ARCHITECT'S SUPPLEMENTAL INSTRUCTIONS

Table with project details: PROJECT: The Irving Lofts, OWNER: OPG Irving Partners, LLC, CONTRACTOR: MCP Group, Report No. Three (3), Date July 1, 2026, Architect's Proj No. 24-3479, Contract For: General Construction Mechanical, Electrical

THE IRVING LOFTS
 HISTORIC RESTORATION & REHAB APARTMENTS
 CLEBURNE, TEXAS

AA2.1

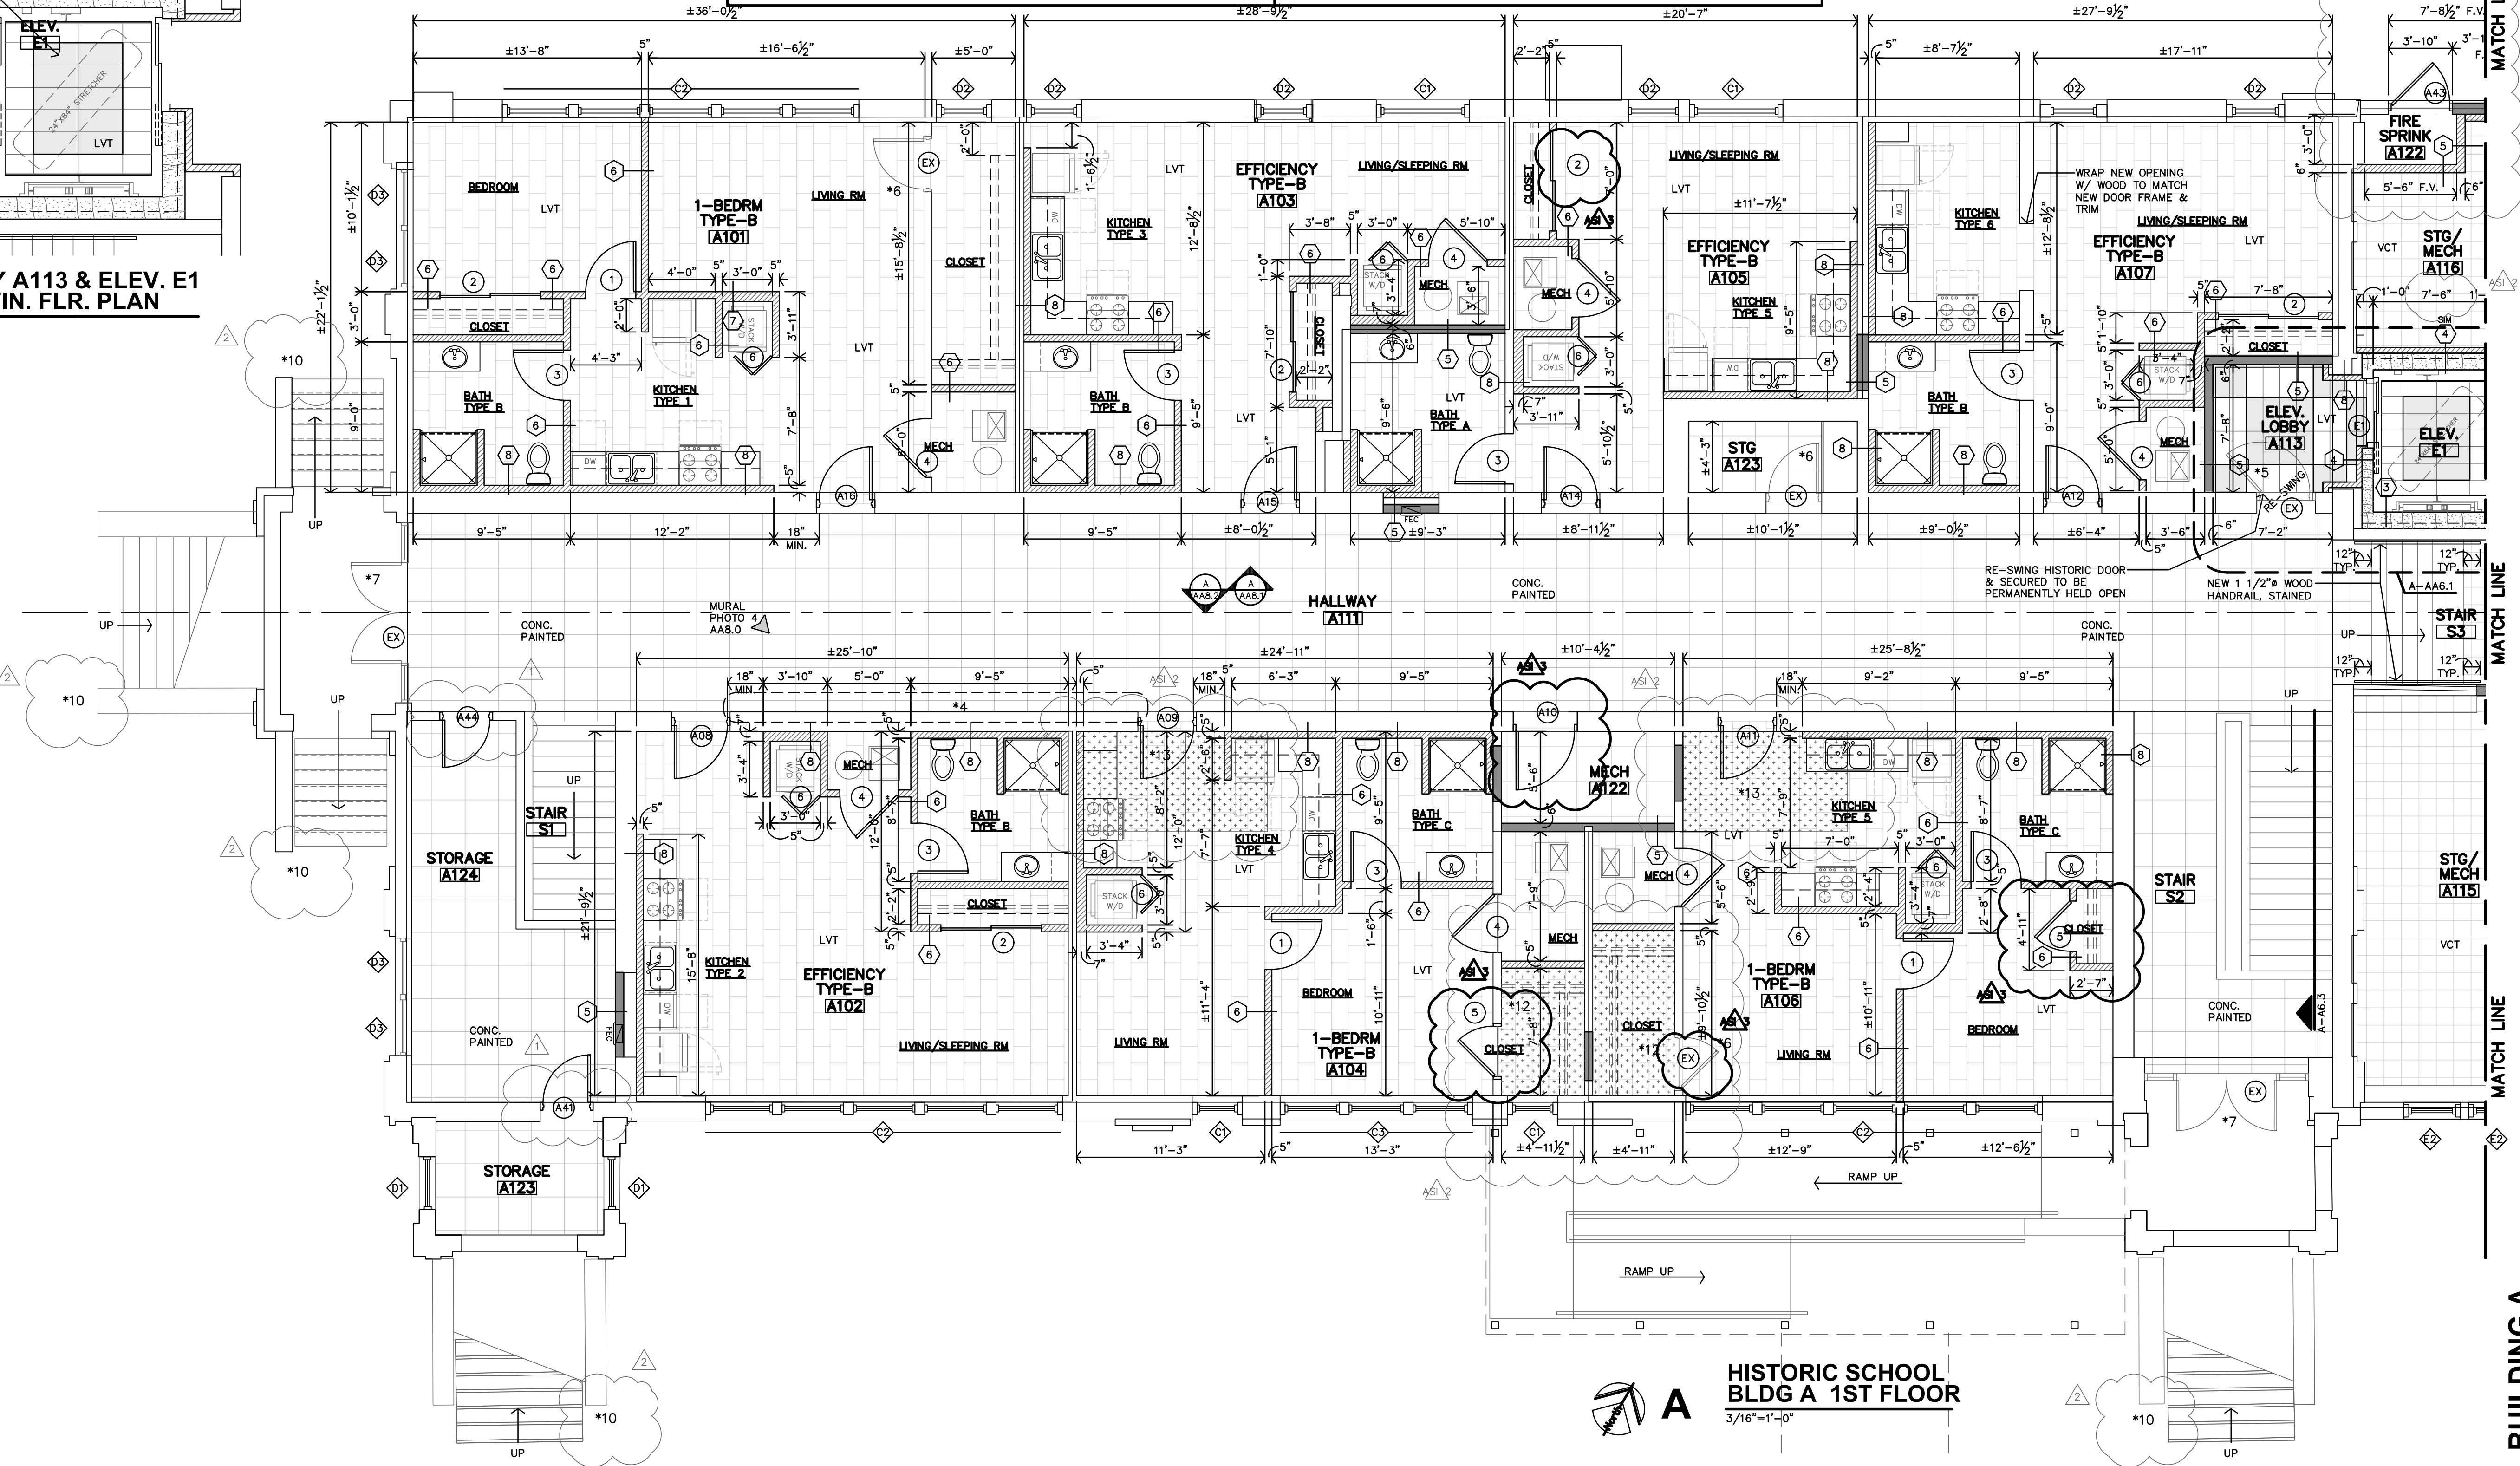
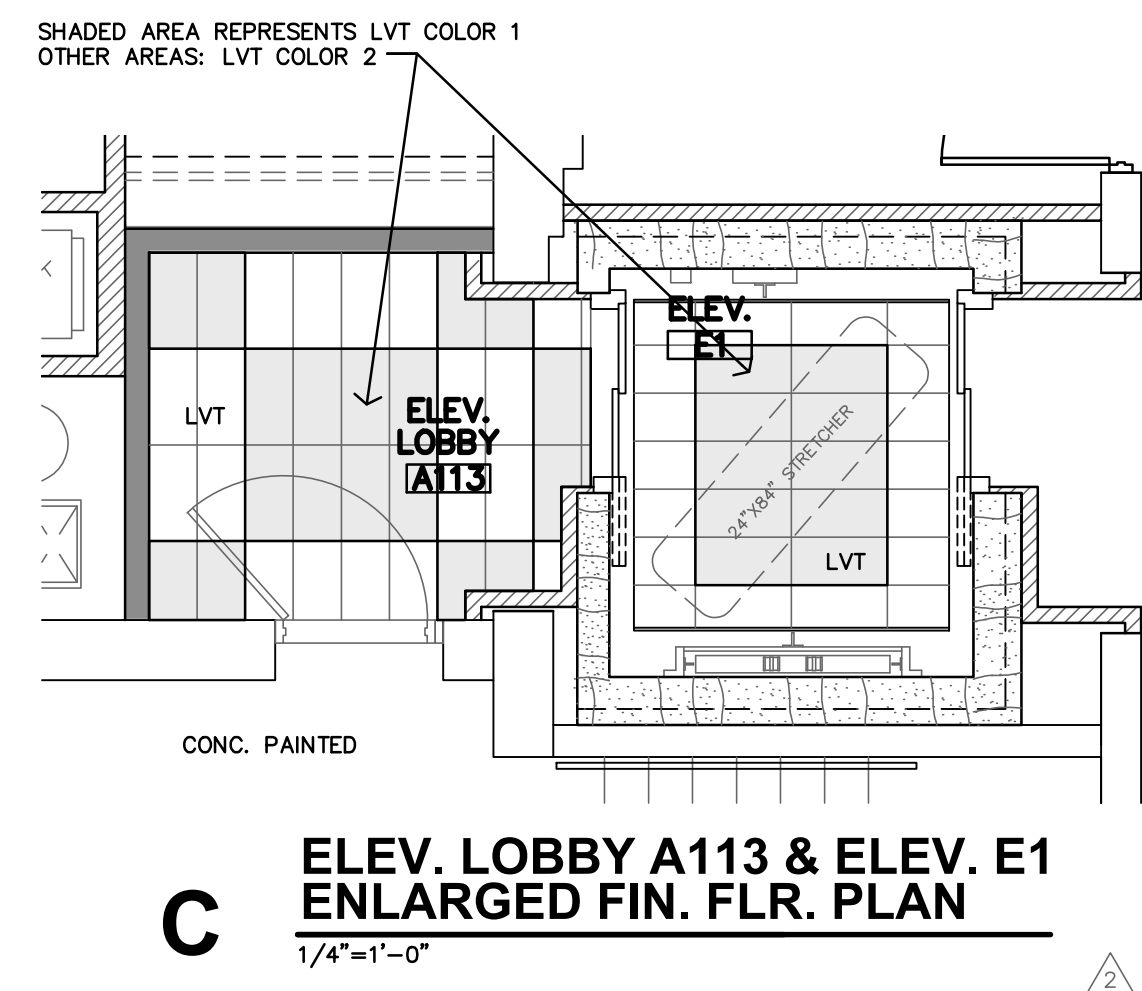
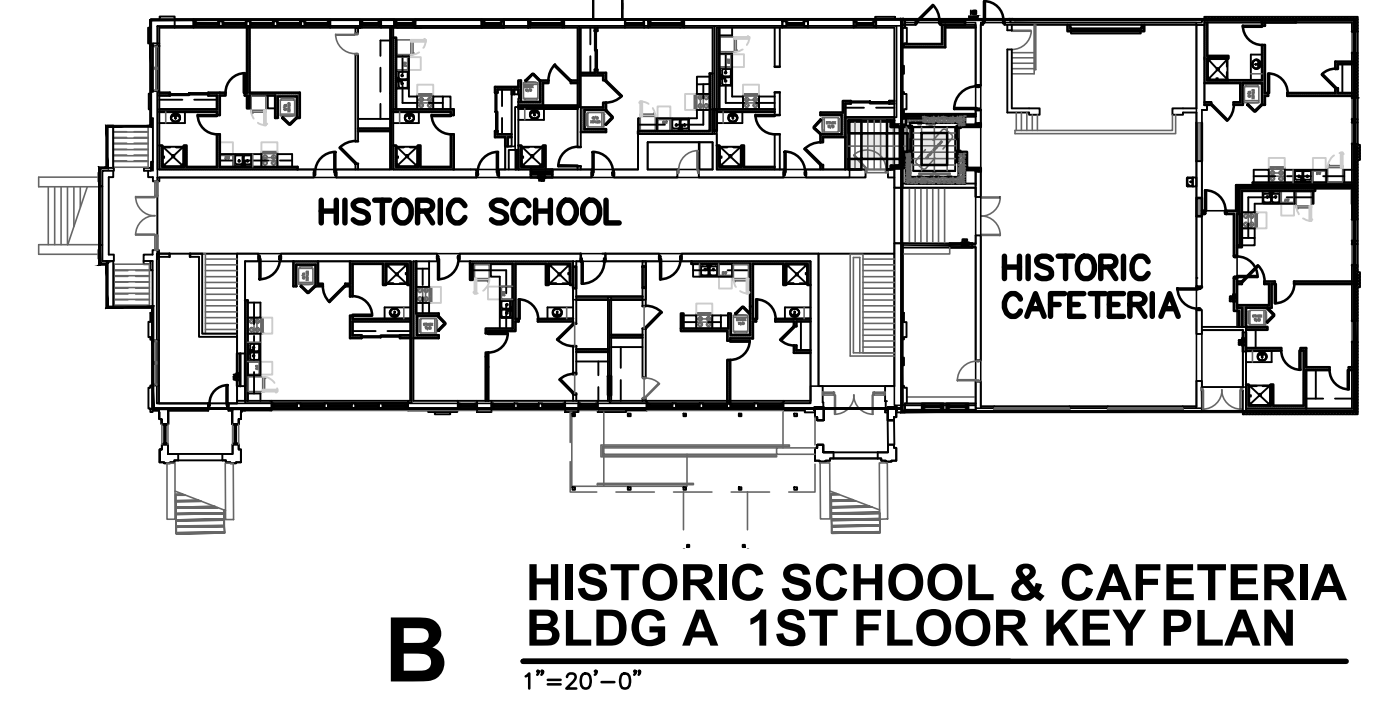
- 1) Contractor to make adjustments as needed and required per the modifications as indicated on attached drawings and in the below descriptions:
a. Sheet AA2.1

i. Door A10 - adjusted size to 3'-6" wide
ii. Unit A104 - Bedroom closet door revised to type '5'.
iii. Unit A105 - Door type '2' added to closet door.
iv. Unit A106 - Living Room closet door revised to type 'EX'; Bedroom closet door revised to type '5'.

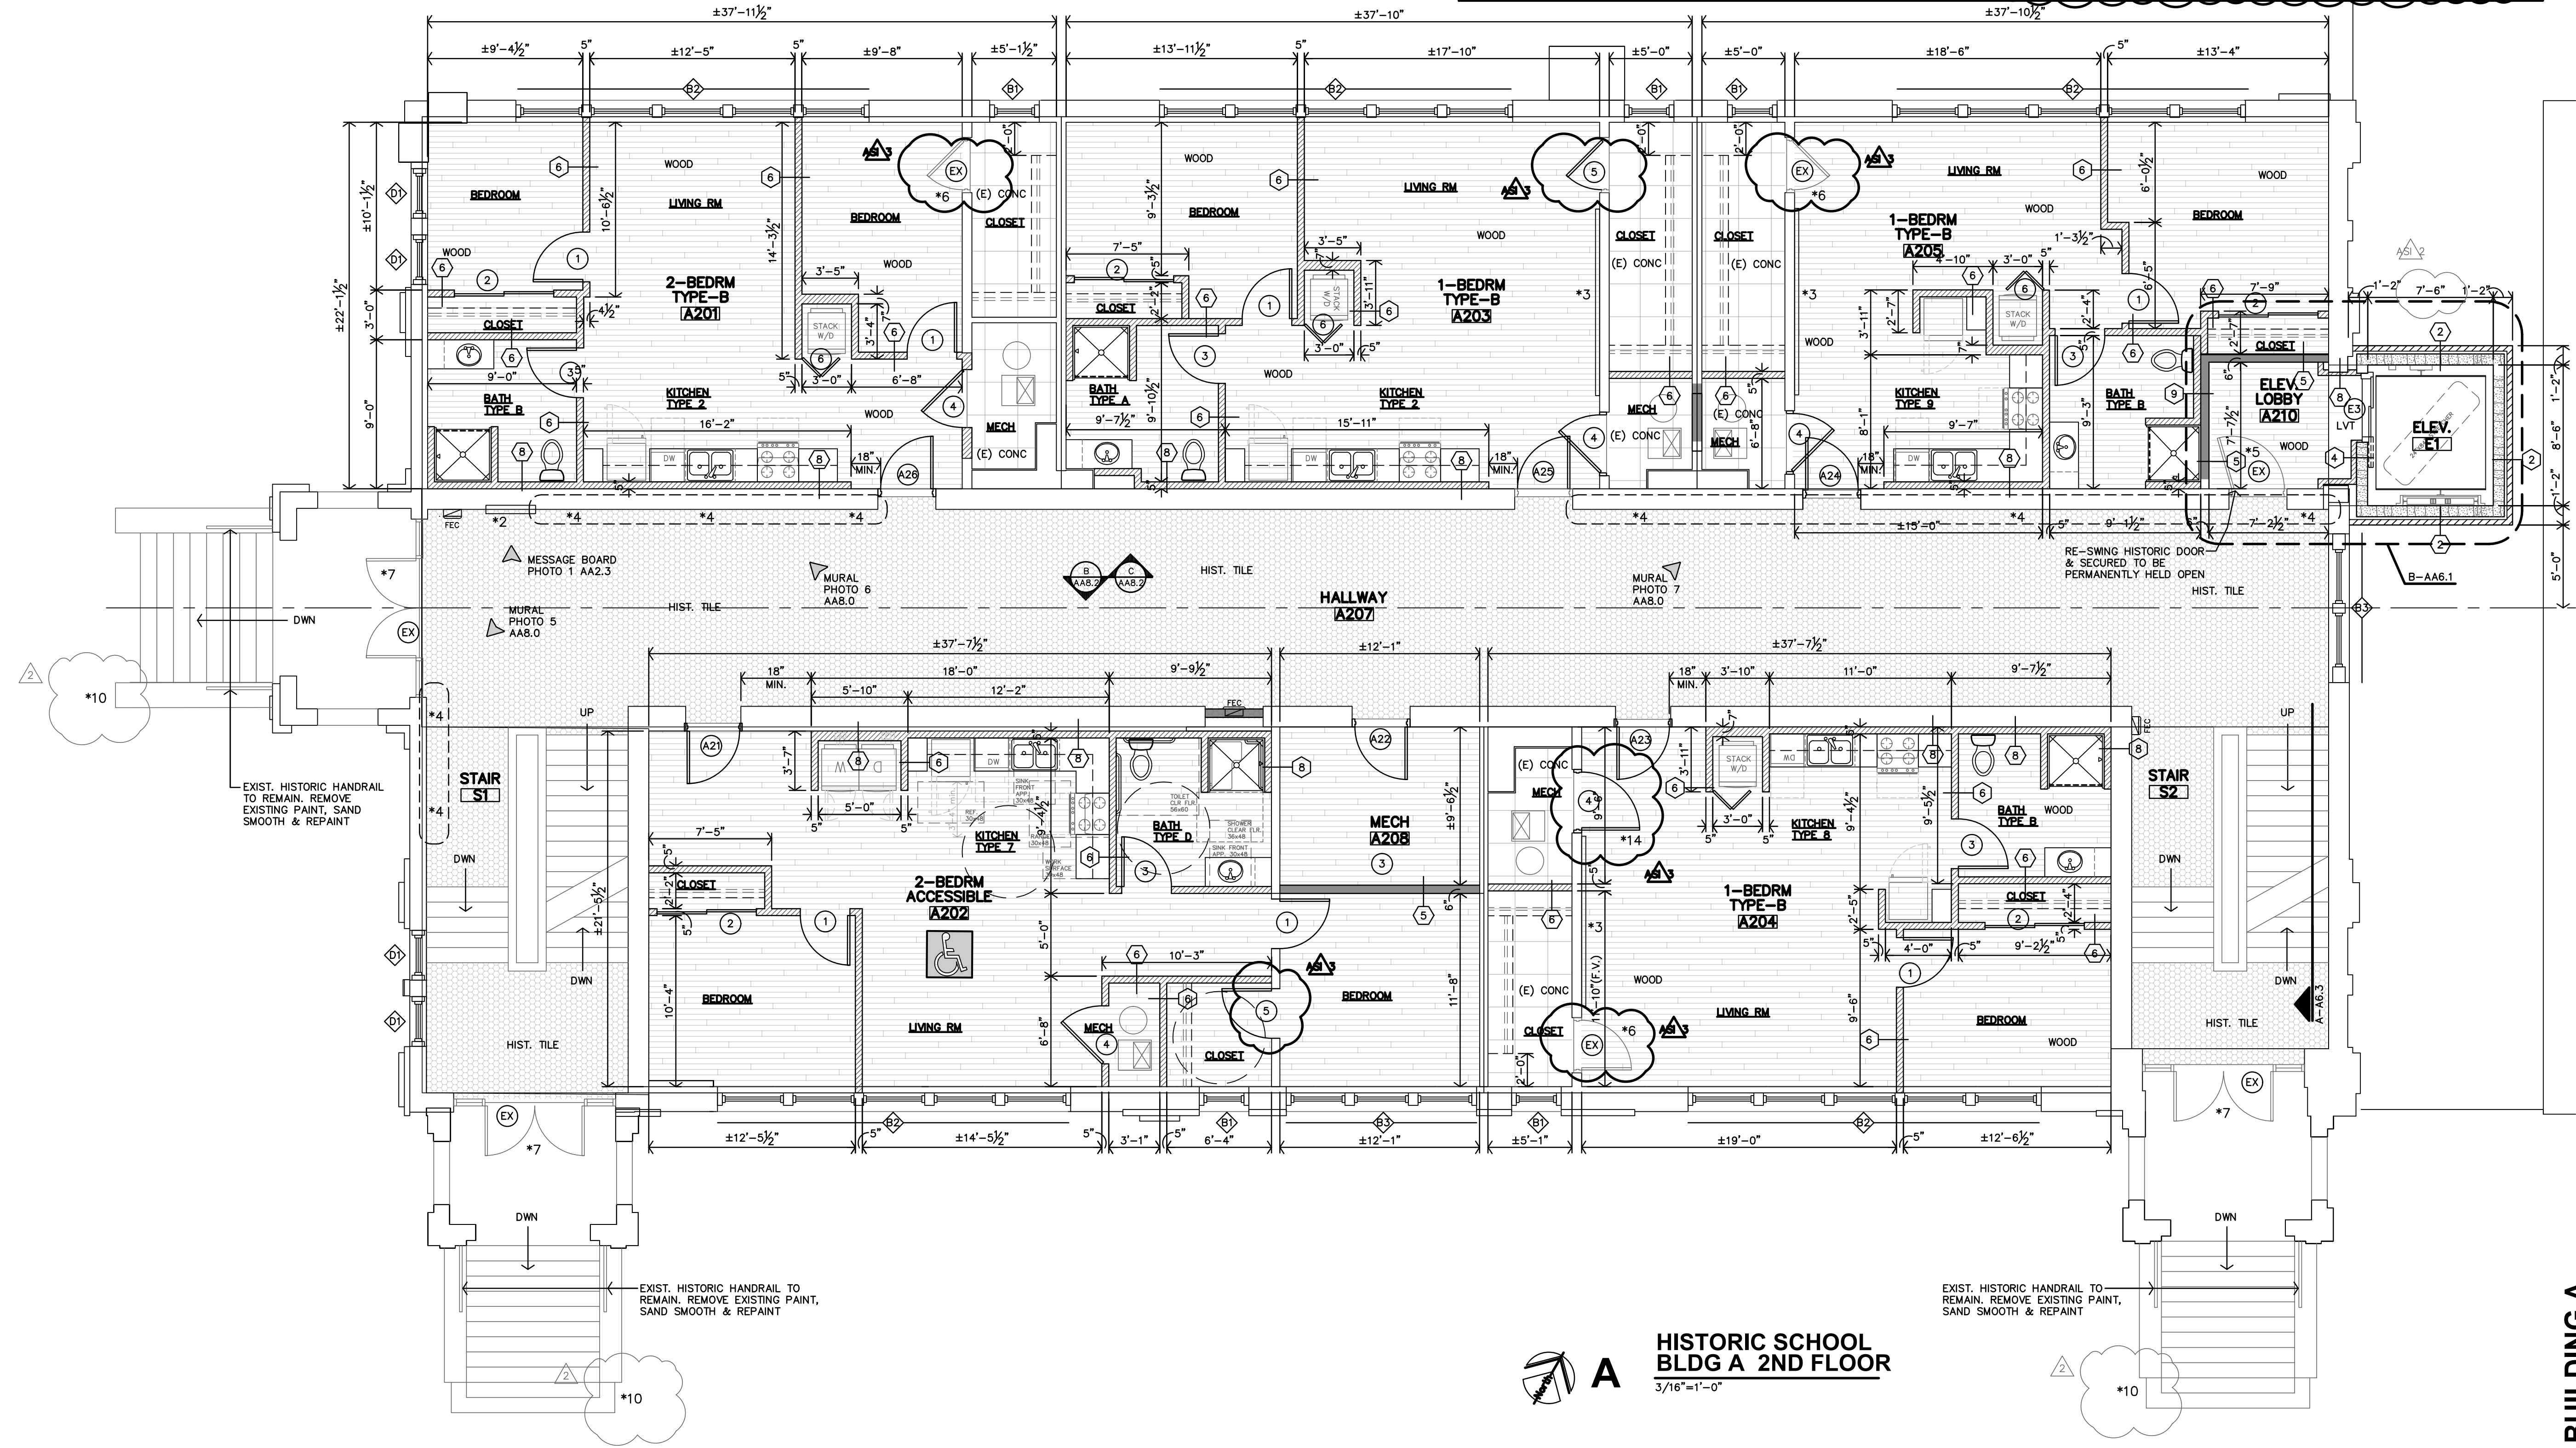
c. Sheet AA2.3
i. Historic Restoration & Rehab Notes - Specific Notes - Note 14 has been added
ii. Unit A201 - bedroom closet door revised to type 'EX'
iii. Unit A202 - bedroom closet door revised to type '5'
iv. Unit A203 - living room closet door revised to type '5'

v. Unit A204 - living room closet door revised to type 'EX'; mechanical closet door adjusted size to 3'-6" and added Note 14
vi. Unit A205 - living room closet door revised to type 'EX'
